McCULLOCH CORPORATION
SERVICE BULLETIN

1529

MODEL: SP 80

SUBJECT: ADAPTING THE SP 80 FOR THE PRO MAC BAR

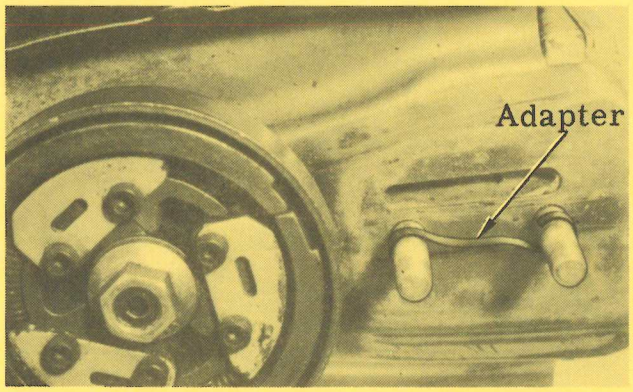
1. Invert the bar adjusting nut on the clutch guard so that the tang is at the bottom of the slot.
